SI B63 13 14
Lights

Service Action: Radio Reception Interference Due to Taillight

F16 (X6)

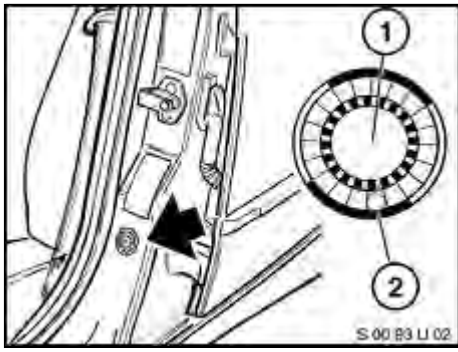
Replace the left rear light unit on the tailgate following ISTA Repair Instructions REP 63 21 245 or the repair instructions attached to this Service Information bulletin.
